**ISLE OF PALMS PHASE 3
INTERNAL DRAINAGE IMPROVEMENTS**

**T&H PROJECT NO.
J-27670.0003**

ADDENDUM NO. 1

October 23, 2020

U1.3

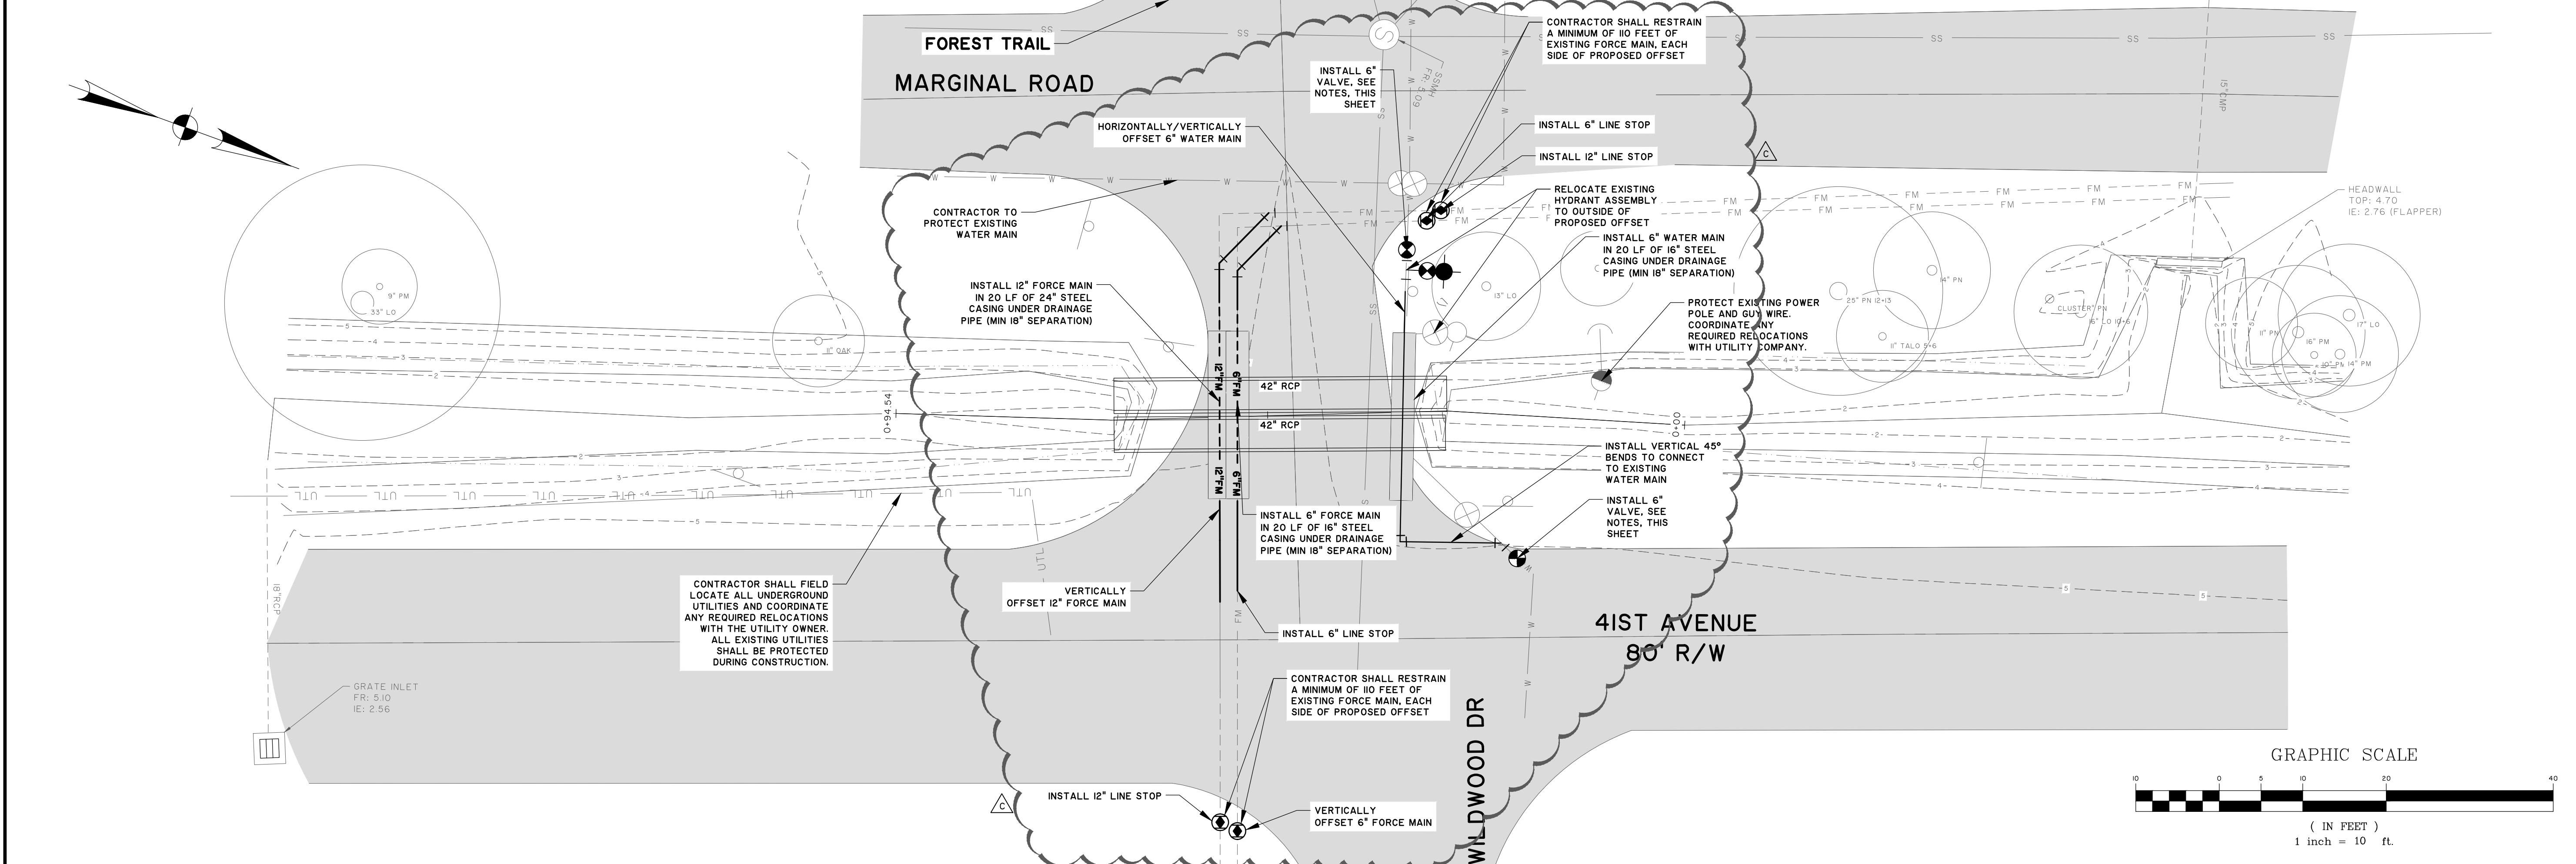
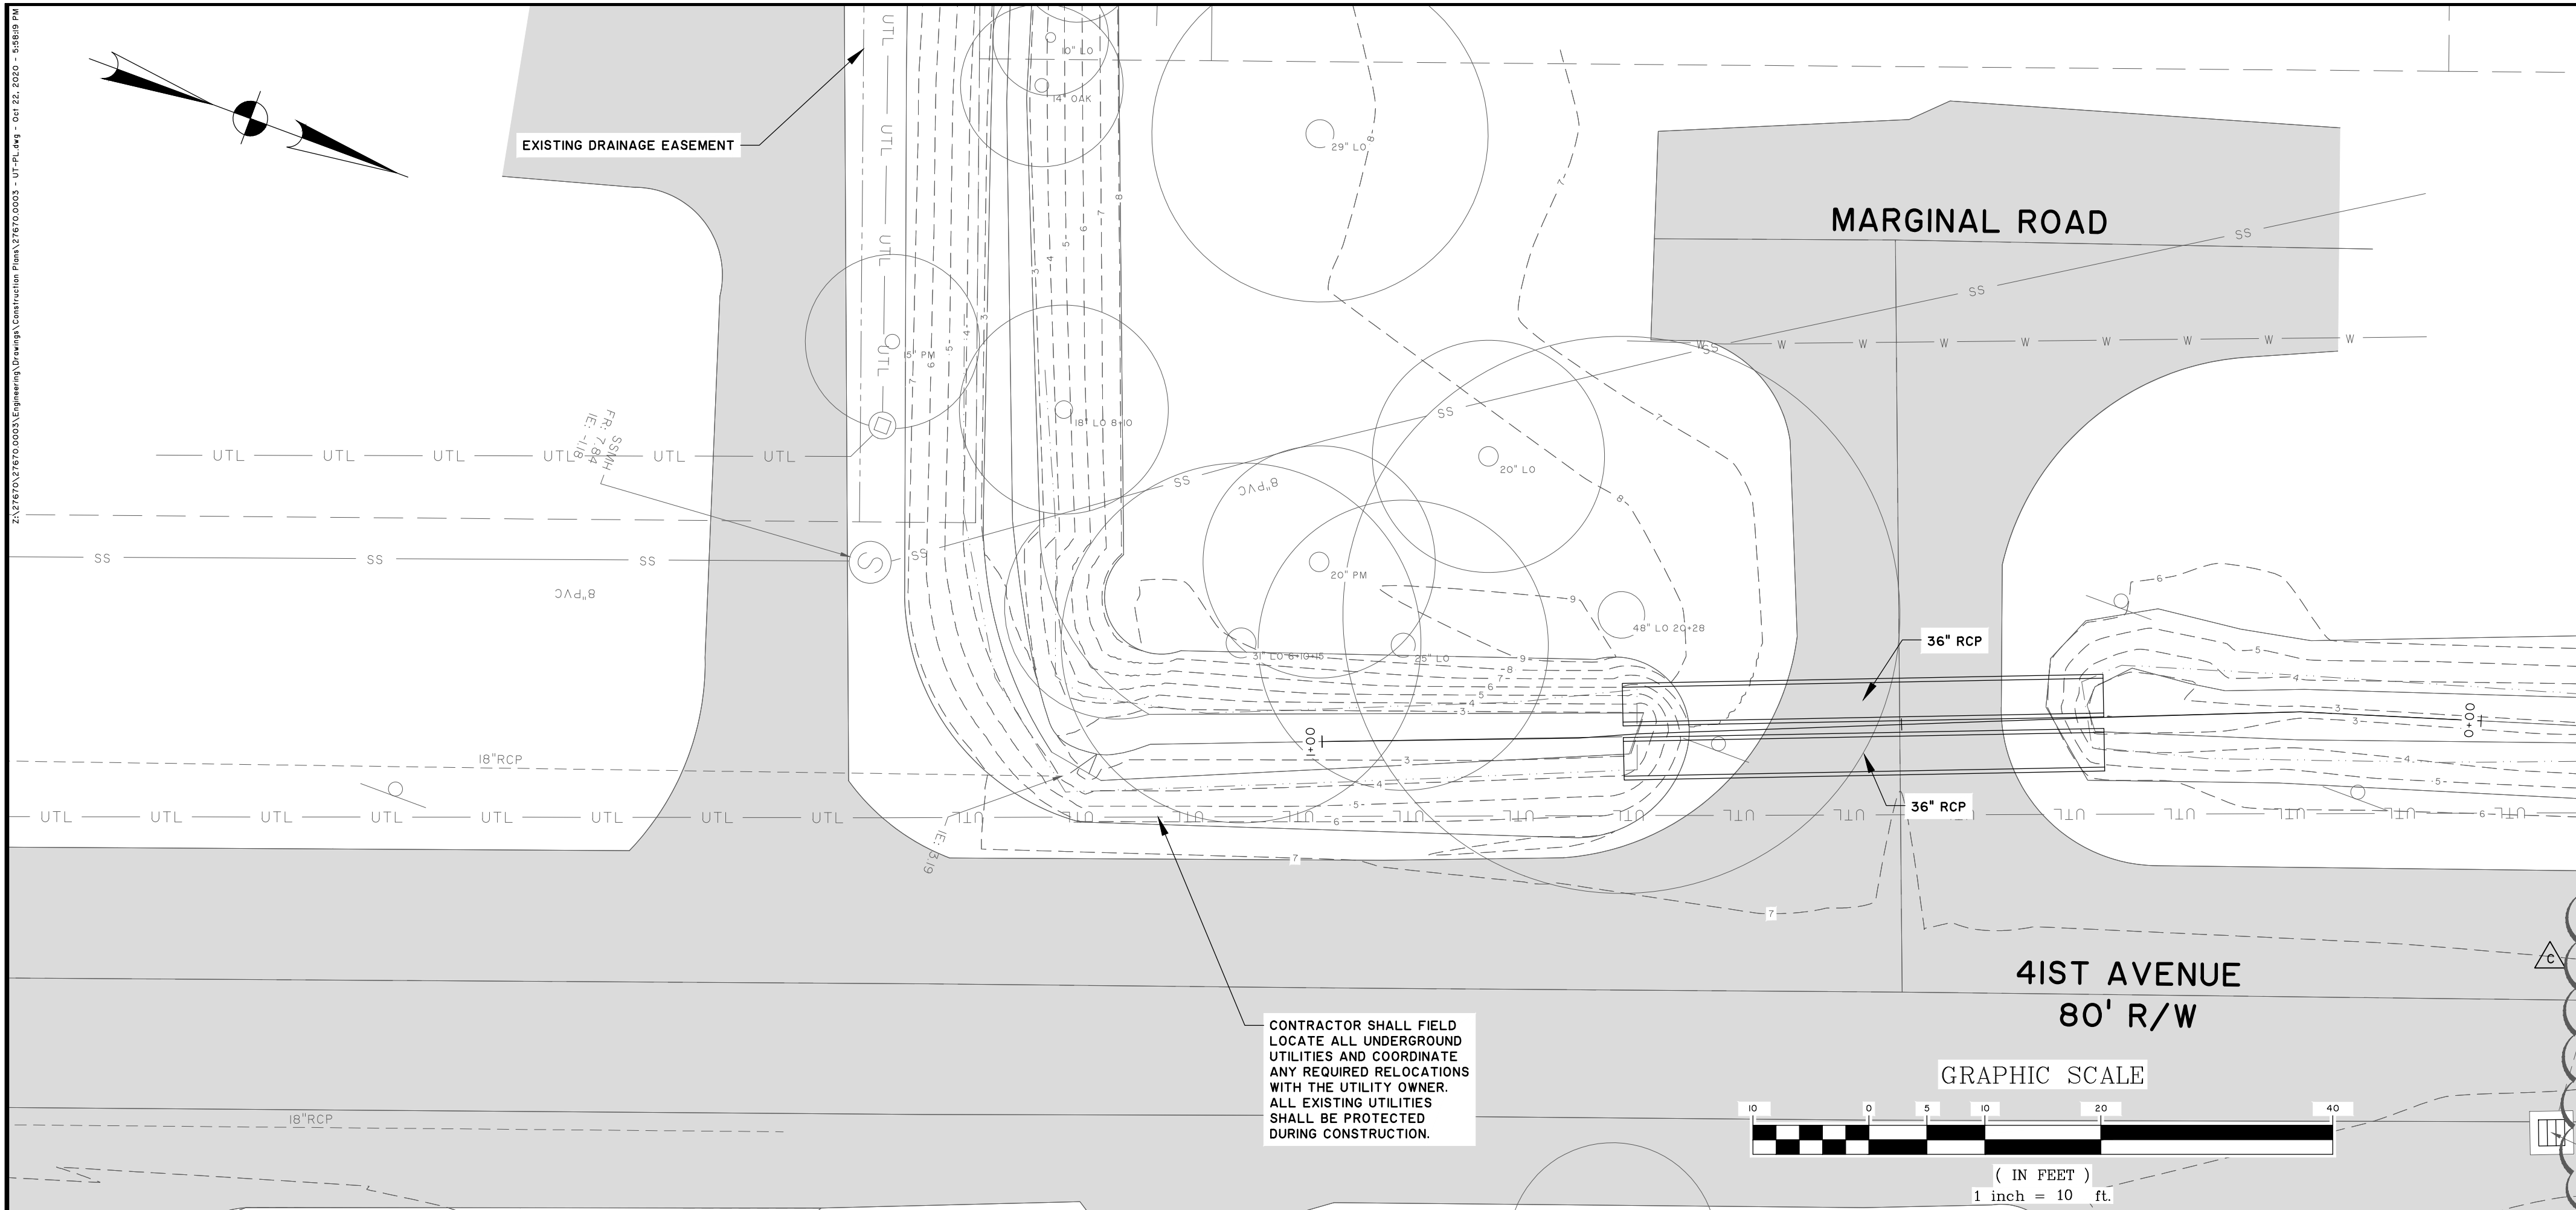
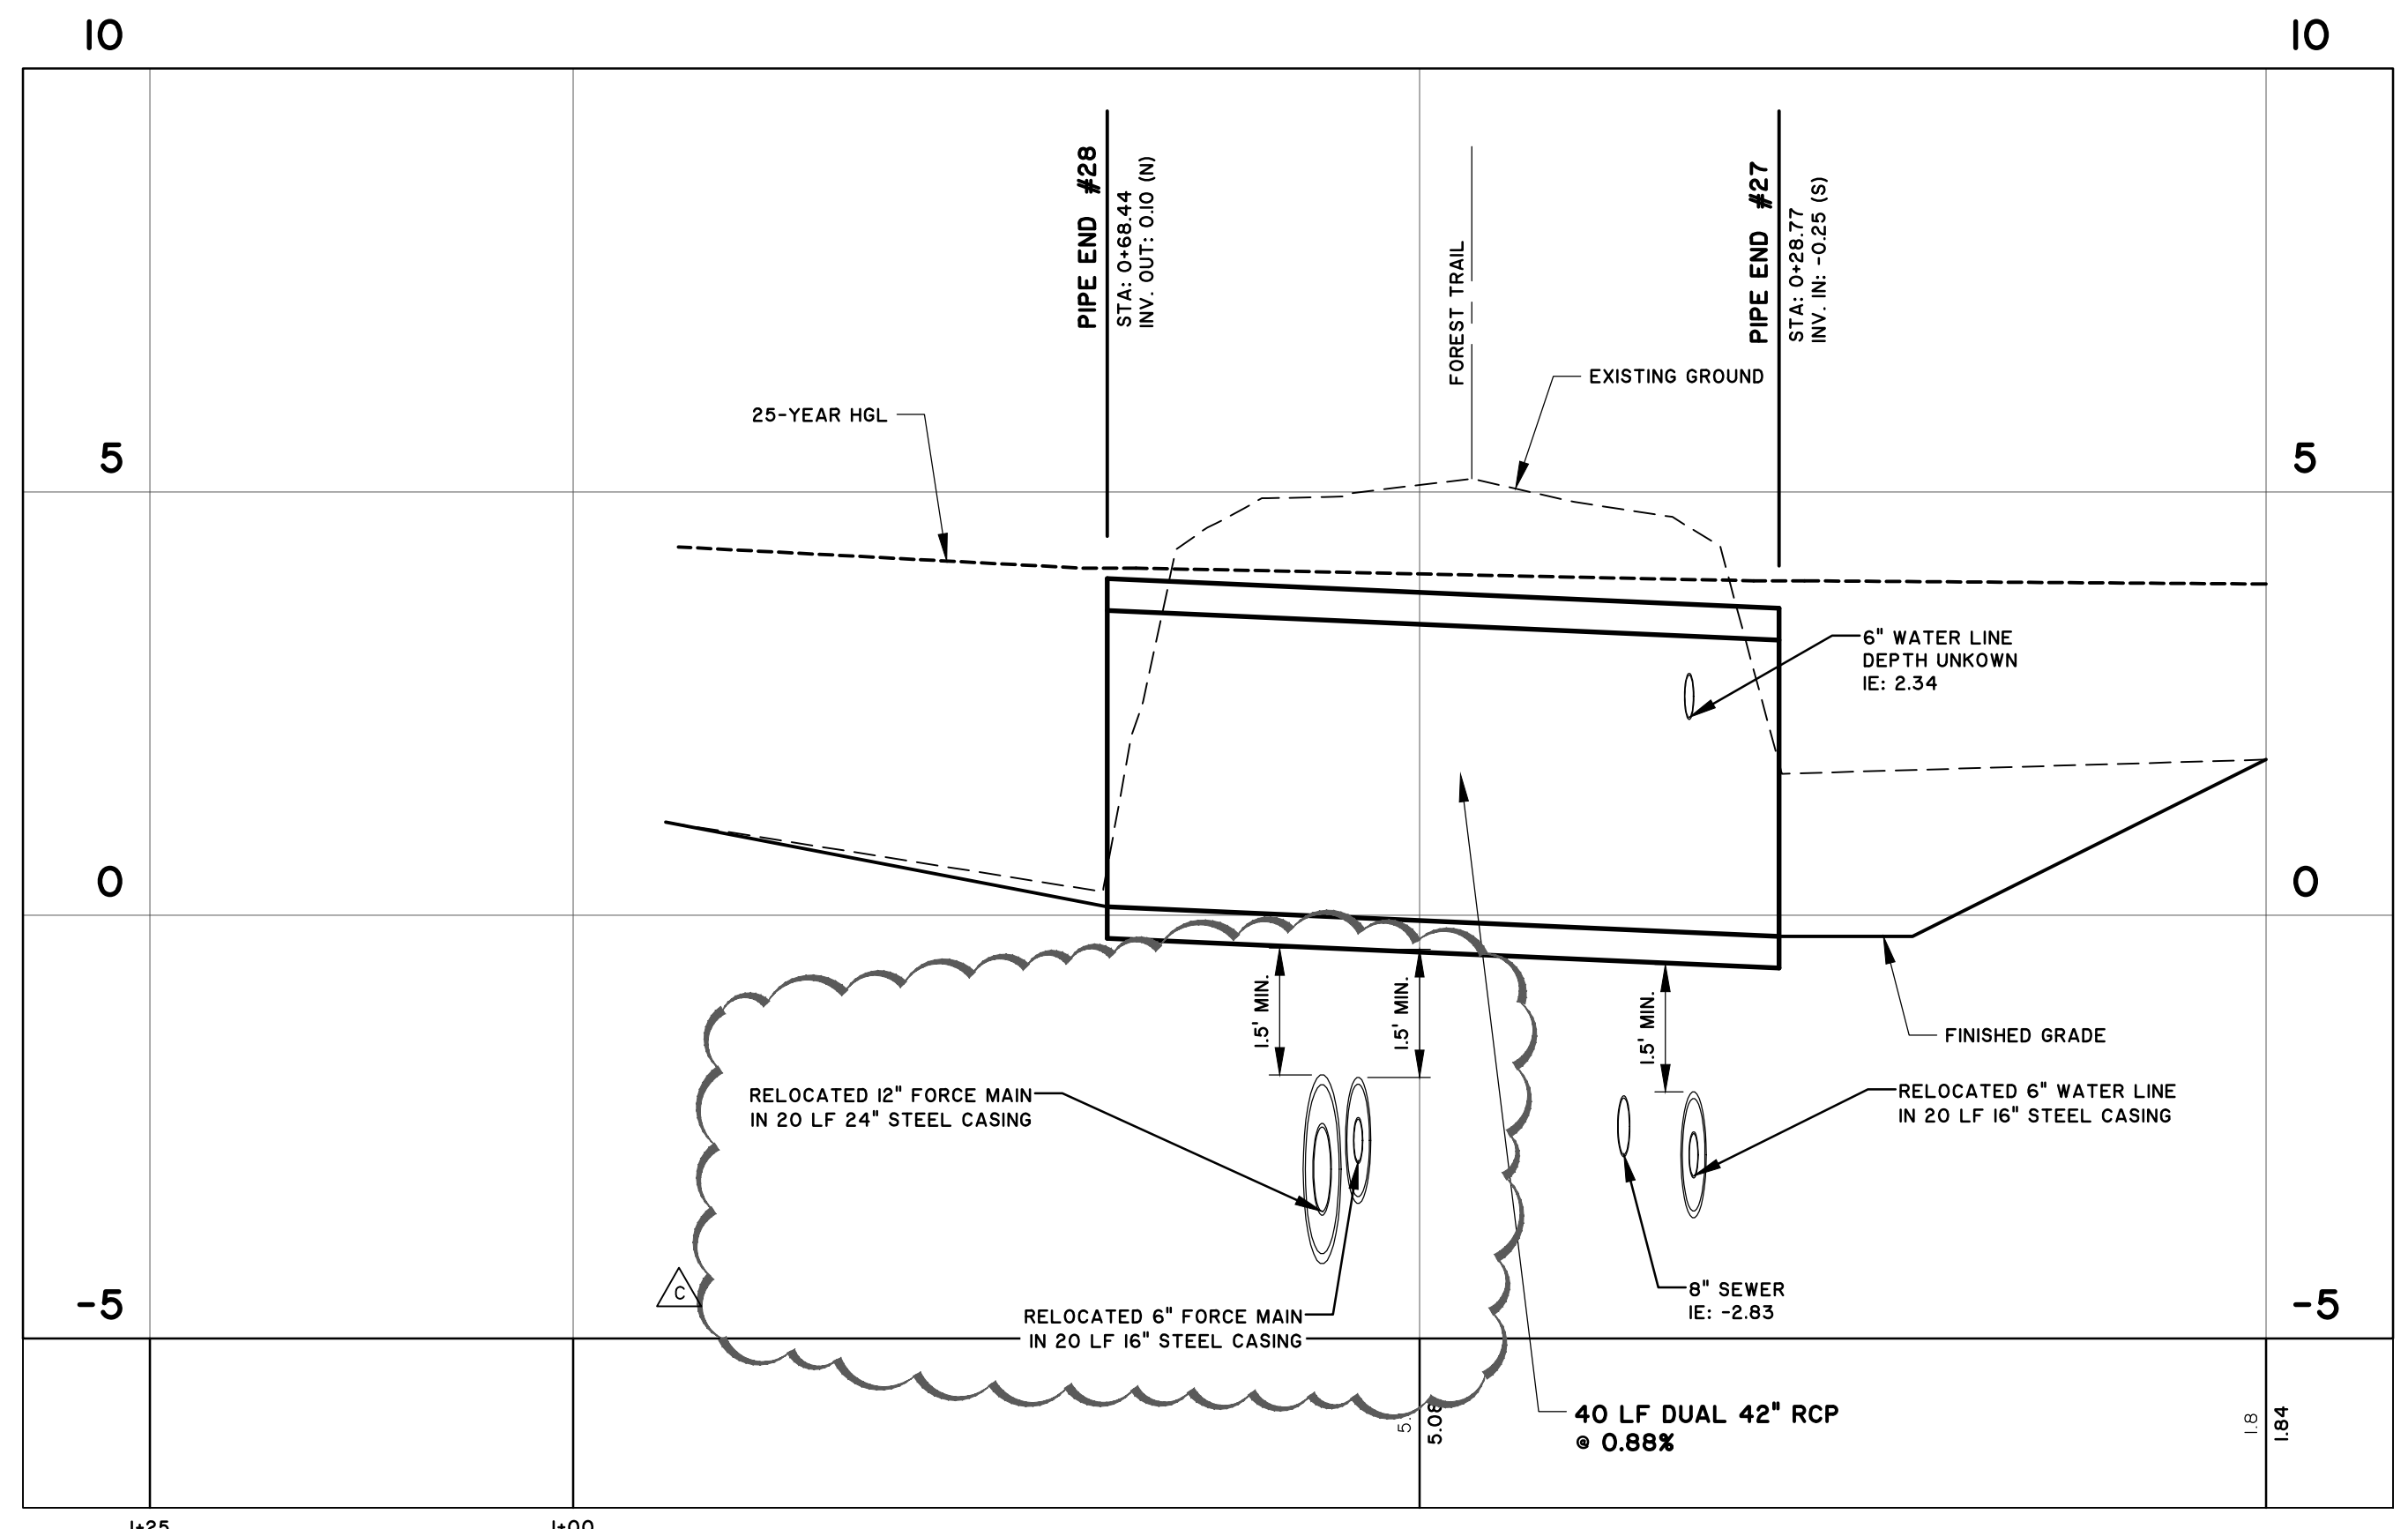
1. Note **12** on Sheet **U1.3** has been revised as follows:

Contractor shall install line stops in each the 6-inch forcemain and the 12-inch forcemain (2 per forcemain, either side of proposed offset).

2. The following has been added as Note **13** to the plan sheet **U1.3**:

Contractor shall provide a minimum of 14 calendar days notice to IOPWSC and shall coordinate with IOPWSC for the cleaning of the 12-inch and 6-inch forcemains. After the installation of the line stops and the removal of the existing forcemains, the contractor shall allow IOPWSC access to the work site (while the trench is open) to clean the forcemains. An appropriate amount of time (minimum of 3 days) shall be allotted to IOPWSC for the cleaning. IOPWSC shall be responsible for all work associated with cleaning the lines – including collecting and disposal of fluids and maintenance of trench during cleaning activities.

3. The following has been added as Note **14** to the plan sheet **U1.3**:

It is believed that flowable fill was installed as backfill (around and above) the existing 6" and 12" force mains noted on this page where the utilities are located under existing pavement. Contractor shall remove all flowable fill around and above the sections of the force mains noted to be relocated under the proposed drainage culverts. Contractor shall provide suitable backfill material and shall place and compact the material to conform to the requirements noted in Section 02731.

The cost for removal and offsite disposal of the existing flowable fill, along with the supply, placement, and compaction of suitable backfill material shall be considered inclusive of the "Utility Work Within Project Area" line item.

4. The locations of the line stops and the relocation of the force mains have been revised on plan sheets **U1.3** and **C1.6**.

- CONTRACTOR SHALL INSTALL LINE STOPS IN EACH THE 6-INCH FORCEMAIN AND THE 12-INCH FORCEMAIN (2 PER FORCEMAIN, EITHER SIDE OF PROPOSED OFFSET).
- CONTRACTOR SHALL PROVIDE A MINIMUM OF 14 CALENDAR DAYS NOTICE TO IOPWSC AND SHALL COORDINATE WITH IOPWSC FOR THE CLEANING OF THE 12-INCH AND 6-INCH FORCEMANS. AFTER THE INSTALLATION OF THE LINE STOPS AND THE REMOVAL OF THE EXISTING FORCEMANS, THE CONTRACTOR SHALL ALLOW IOPWSC ACCESS TO THE WORK SITE (WHILE THE TRENCH IS OPEN) TO CLEAN THE FORCEMANS. AN APPROPRIATE AMOUNT OF TIME (MINIMUM OF 3 DAYS) SHALL BE ALLOTTED TO IOPWSC FOR THE CLEANING. IOPWSC SHALL BE RESPONSIBLE FOR ALL WORK ASSOCIATED WITH CLEANING THE LINES - INCLUDING COLLECTING AND DISPOSAL OF FLUIDS AND MAINTENANCE OF TRENCH DURING CLEANING ACTIVITIES.

- IT IS BELIEVED THAT FLOWABLE FILL WAS INSTALLED AS BACKFILL (AROUND AND ABOVE) THE EXISTING 6" AND 12" FORCE MAINS NOTED ON THIS PAGE WHERE THE UTILITIES ARE LOCATED UNDER EXISTING PAVEMENT. CONTRACTOR SHALL REMOVE ALL FLOWABLE FILL AROUND AND ABOVE THE SECTIONS OF THE FORCE MAINS NOTED TO BE RELOCATED UNDER THE PROPOSED DRAINAGE CULVERTS. CONTRACTOR SHALL PROVIDE SUITABLE BACKFILL MATERIAL AND SHALL PLACE AND COMPACT THE MATERIAL TO CONFORM TO THE REQUIREMENTS NOTED IN SECTION 02731.

- THE COST FOR REMOVAL AND OFFSITE DISPOSAL OF THE EXISTING FLOWABLE FILL, ALONG WITH THE SUPPLY, PLACEMENT, AND COMPACTION OF SUITABLE BACKFILL MATERIAL SHALL BE CONSIDERED INCLUSIVE OF THE "UTILITY WORK WITHIN PROJECT AREA" LINE ITEM.
